**Environmental permit application EPR/YP3735YK/A001**

**to drill at Leith Hill, Surrey:**

**Response to the Environment Agency in the context**

**of relevant geology and hydrogeology**

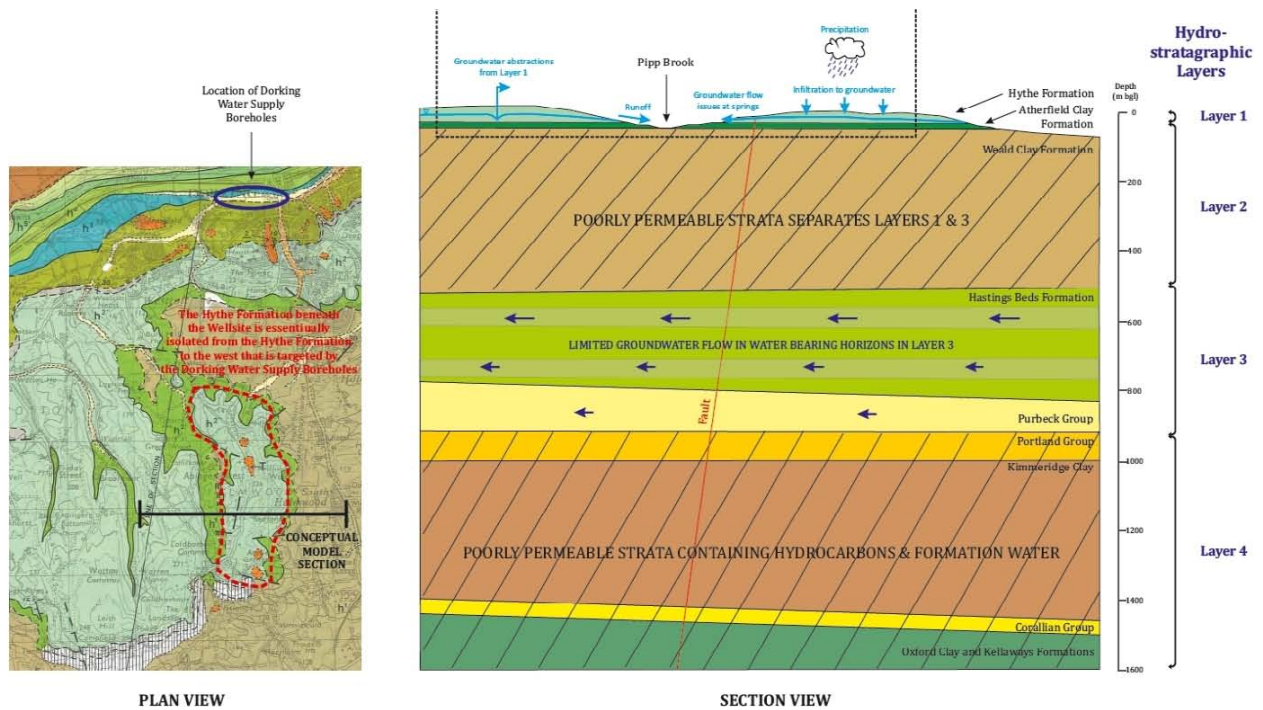
There are several serious errors with this model. Firstly, it relies on an out-of-date version of the solid geology, the Reigate sheet no. 286, for which the geological field mapping was carried out 90 years or more ago. As a result, the E-W cross-section shown in Envireau's figure 4a is inaccurate. In addition, the claim that there is no groundwater pathway between the well site and the public water supply is incorrect.

Figure 6.2. a. Contour map of the Base Hythe Formation, labelled in meters above sea level, on the BGS roaming solid and superficial geology image. The Hythe Formation is shown in bright green, the underlying Atherfield Clay in darker green.

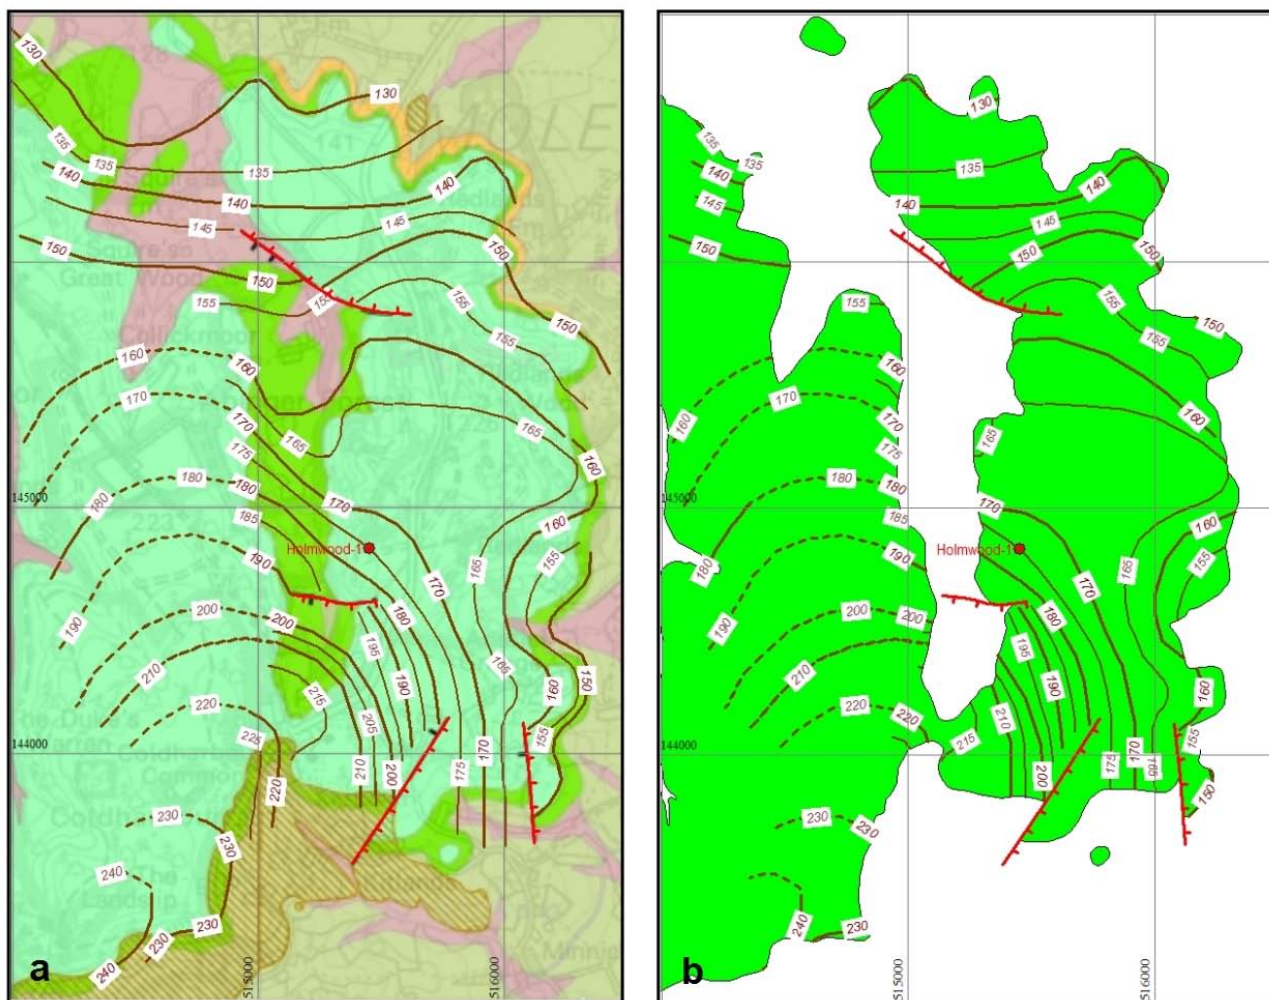
It must be noted that the linear features, including faults, in the BGS digital database do not necessarily show the correct sense of throw. The BGS roaming images constructed from this database have about 50% of the faults showing a throw in the wrong sense. I communicated this problem to Professor John Ludden, Executive Director of the BGS, a couple of years ago. The faults need to be individually examined in context in order for the correct throw sense to be marked.

Three of the four faults in Figure 6.2a have the wrong sense of throw, as can be discerned from the black tick mark visible from the underlying roam image. Only the E-W fault just south of the wellsite is correct. The contours run into the air across the Pipp Brook valley; this is done for continuity; the resulting map with the above-ground contours cropped to the Hythe outcrop is shown in Figure 6.2b.

It is evident from the contours that the E-W cross-section by Envireau is seriously defective. Furthermore, the statement by Envireau that there may be unmapped springs along the western edge of the Hythe outcrop is incorrect, since the consistent easterly to north-easterly dip of the Base Hythe horizon explains why there are no springs just west of the drillsite. This is shown in Figure 6.3, where all the springs, wells and issues taken from the OS 10K map have been marked.

Figure 6.3. Springs and issues (spouting water symbol) around the Hythe Formation outcrop (green). Faults are shown in red; the Applicant's wellsite is shown by the red dot. Superficial deposits are shown by cross-hatching (contains British Geological Survey materials © NERC 2018).

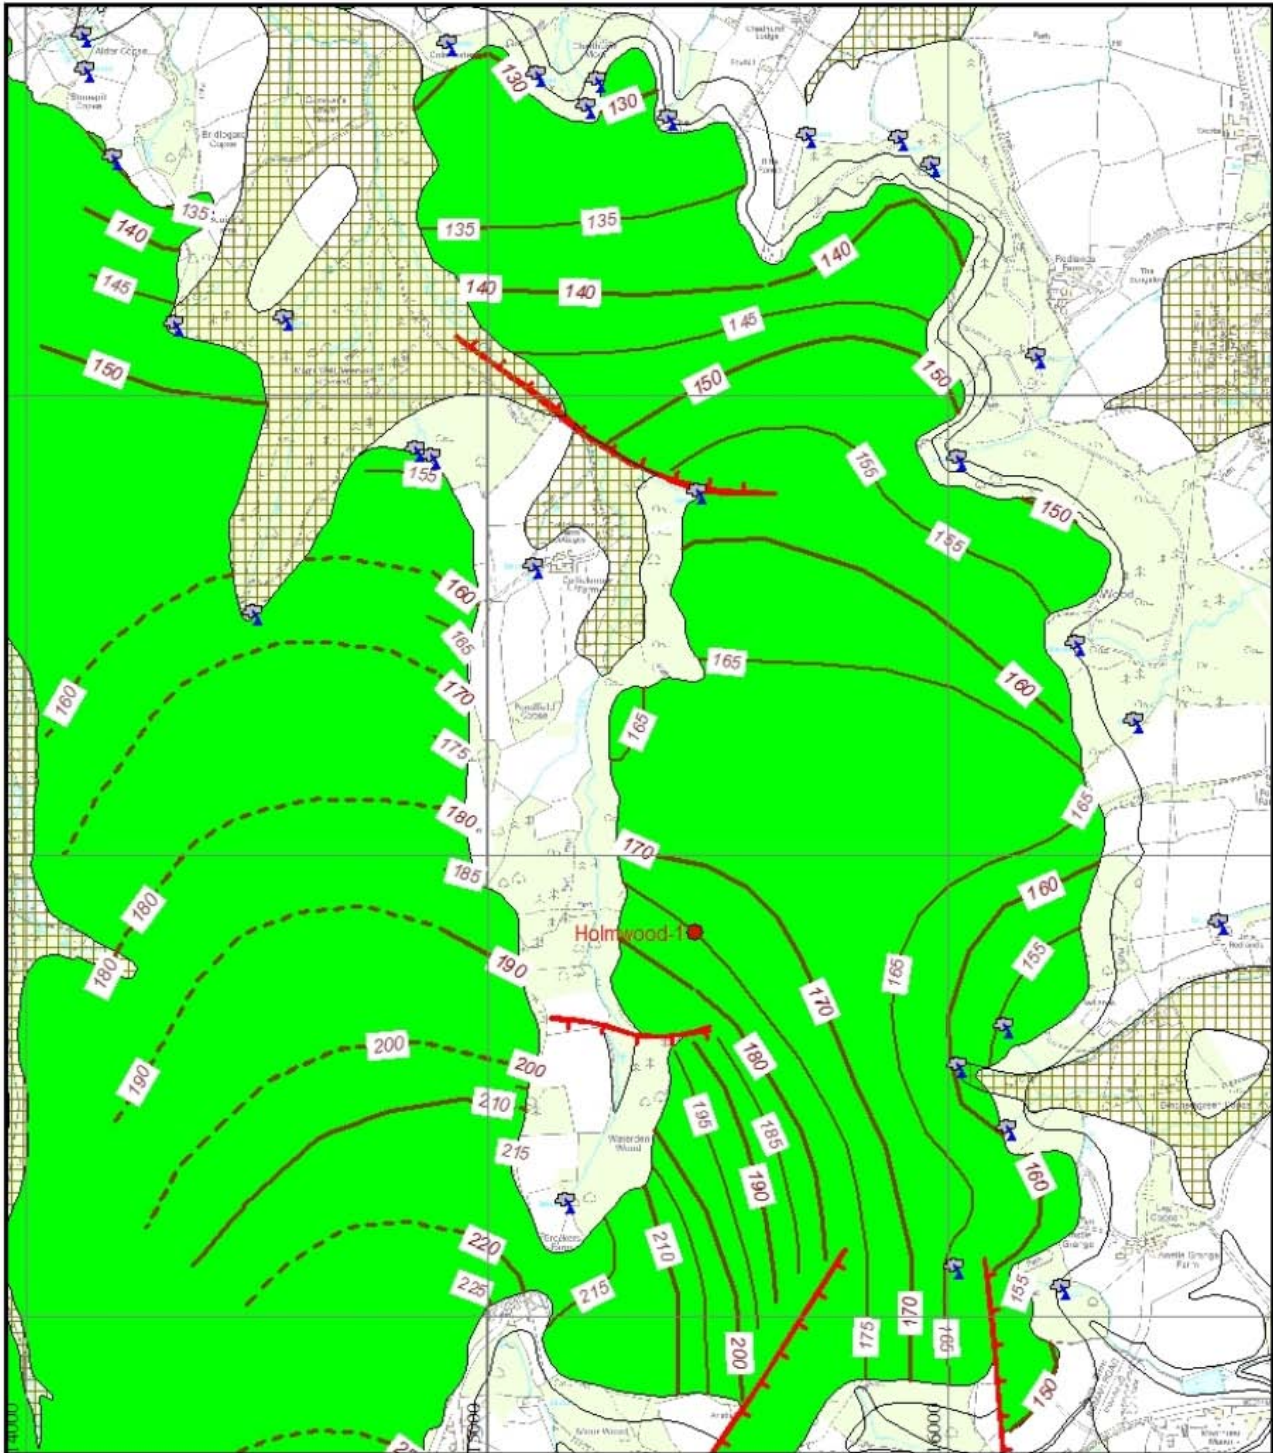
Therefore there are no springs or issues which could be said to originate at the west side of the Hythe Formation outcrop encompassing the wellsite. In contrast there are about ten issues along the eastern flank of the Hythe outcrop to the east of the wellsite, and a further eight along the northern flank, adjacent to where the dip is northerly. In conclusion, the potential problem of contaminated run-off is not to the west, into Pipp Brook, as presumed by the Applicant, but to the east into the Mole catchment.

The Base Hythe Formation is at 175 m (Figure 6.3). The error in this figure is probably no more than  $\pm 1$  m or so. The ground surface at the wellsite is at 219 m, therefore the base of the proposed 50 m of 20 inch conductor casing will be at 169 m above datum. The Hythe Formation is supposed to be protected by a 20 inch conductor casing to a depth of 50 m TVD from ground level (Europa 2018, table 5.1). However, the accurate shallow geological cross-sections of Figures 6.4 and 6.6 show that this is insufficiently long (the red line in the figures). The bottom of the conductor at 169 m ASL terminates within the Atherfield Clay Formation, and does not penetrate through to the top of the Weald Clay at 164 m ASL. Does the Atherfield Clay Formation act as a robust aquitard?

Several of the mapped springs shown in Figure 6.3 around the eastern edge of the Hythe Formation outcrop appear to originate, not at the base of the Hythe, but at the base of the Atherfield Clay Formation. This formation is depicted in Figure 6.3 by the uncoloured narrow outcrop around the edge of the Hythe outcrop. That some of the spring locations are at the base of the Atherfield, and not at the base of the Hythe, has been independently pointed out in the submission by EGG Consulting Limited (EGG 2018, p. 22).

One spring seems to be controlled by a fault. This lies 1 km due north of the wellsite (Figure 6.3). This fault, trending NW-SE, appears on both the old BGS solid geology map and on the new digital database. But other BGS faults are problematic, because many have been modified or removed between the two mapping epochs. The comparison is shown in Figure 6.7. Around the foot of the Leith Hill escarpment the four or five mapped faults have each remained in approximately the same location and with the same sense of downthrow, but with a somewhat different trend. Near to the Applicant's proposed wellsite, more severe changes have been made.

Figure 6.4. Revised and corrected E-W cross-section along the line shown in the map of Figure 6.1 (lower) compared with the Applicant's version (upper) scaled to approximately the same dimensions.

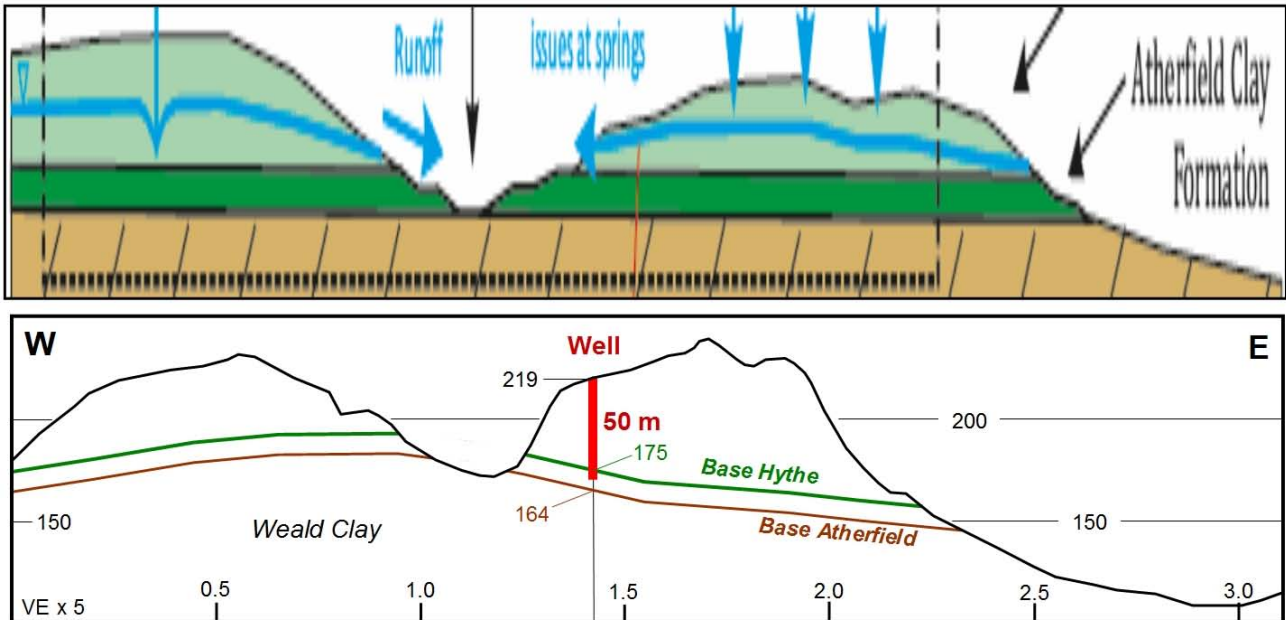
An accurate geological cross-section along the E-W line of Envireau (see Fig. 6.1) is shown in Figure 6.4, at a vertical exaggeration of x5 (lower section) and compared with the Envireau version compressed horizontally to about the same scale (upper section). The main error in the Envireau cross-section lies in portraying the Atherfield Clay as flat-lying in E-W profile.

Figure 6.6. Shallow geological profile along section A-F shown in Figure 6.5. The proposed well is at A. Vertical exaggeration x10.

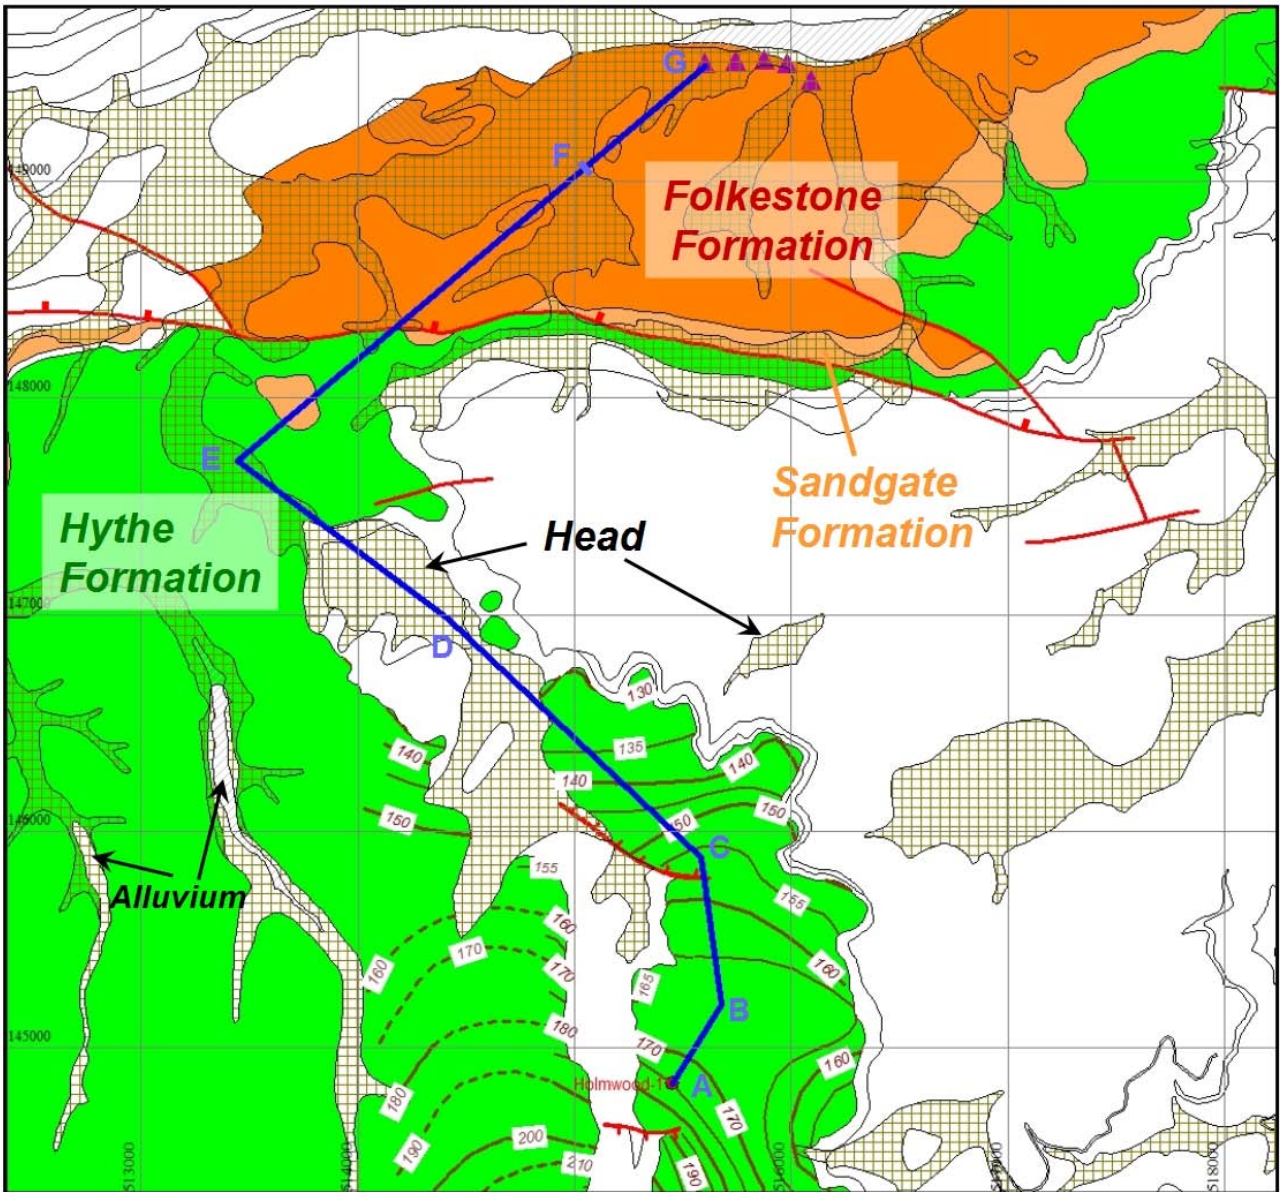
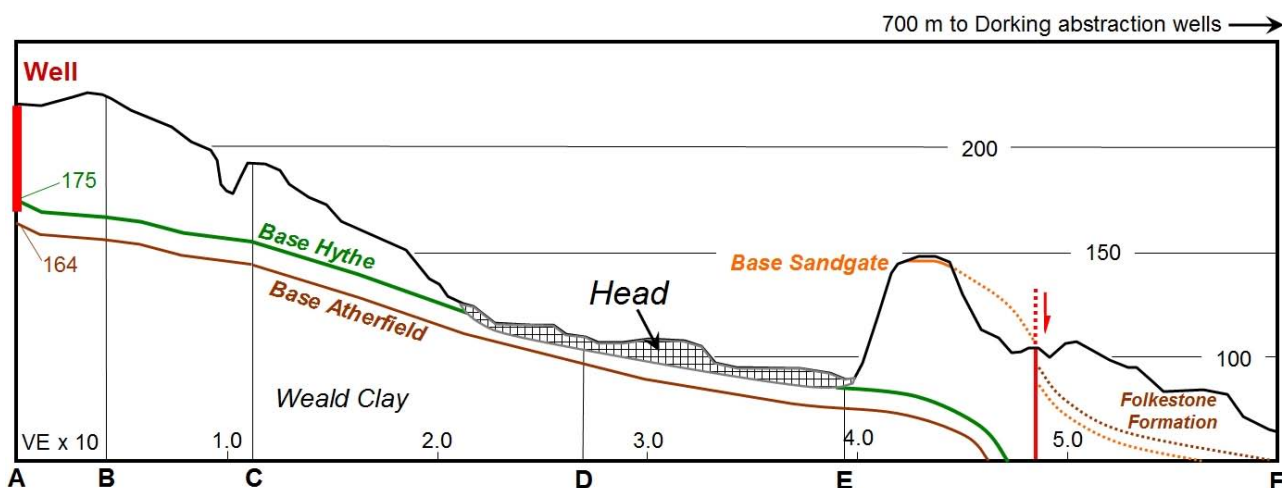
The Applicant asserts that the Hythe Formation outcrop at the wellsite is hydraulically isolated from connection to the public supply boreholes at Dorking. This is incorrect. Figure 6.5 shows a combined solid and superficial geology map, in which only the permeable solid formations have been coloured, and superimposed on those are the superficial Head and Alluvium deposits indicated by cross-hatching. There is a continuous permeable pathway from the well, northwards and with a downdip component, to the water supply boreholes indicated by the mauve triangles at the top of the map. One such path is illustrated in cross-section along the blue line A-G, of which the part A-F is shown in Figure 6.6.

Figure 6.6 shows the connection northwards from the Hythe Formation into the Head, for some 2 km, and then back into the Hythe. The profile is constructed only from points A to F, but the profile continuation to point G, some 700 m further to the NE, stays within the permeable Folkestone Formation at outcrop. Note the presence of the major fault running for some 6 km in an east-west direction through Dorking. This fault was not recognised on the old BGS published 1:50,000 sheet. It cuts a northerly-verging monocline with a downthrow to the north, and in the area of interest it appears to have a vertical component of displacement of at least 20 m, as estimated from nearby outcrops of the Sandgate Formation along either side of the fault trace.

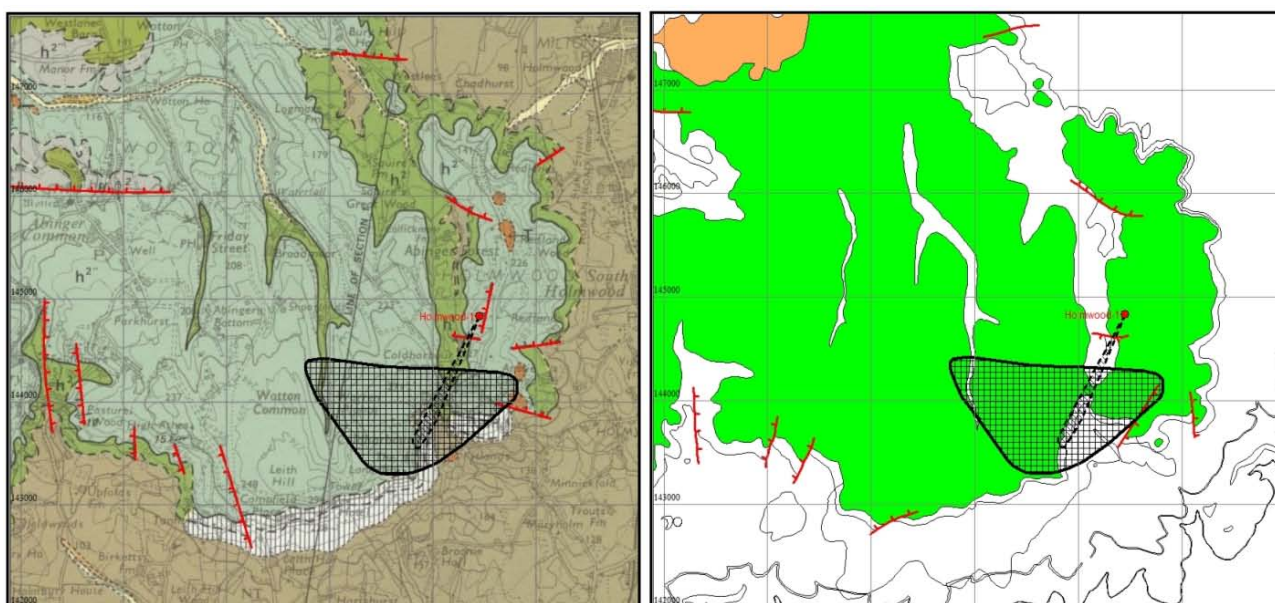
The north-south fault mapped on the 1933 version, very near to the wellsite, is of particular interest and relevance. The memoir for the Reigate sheet (Dines and Edmunds 1933) discusses whether the faults around Leith Hill have resulted in landslips, or have been created by the landslips:
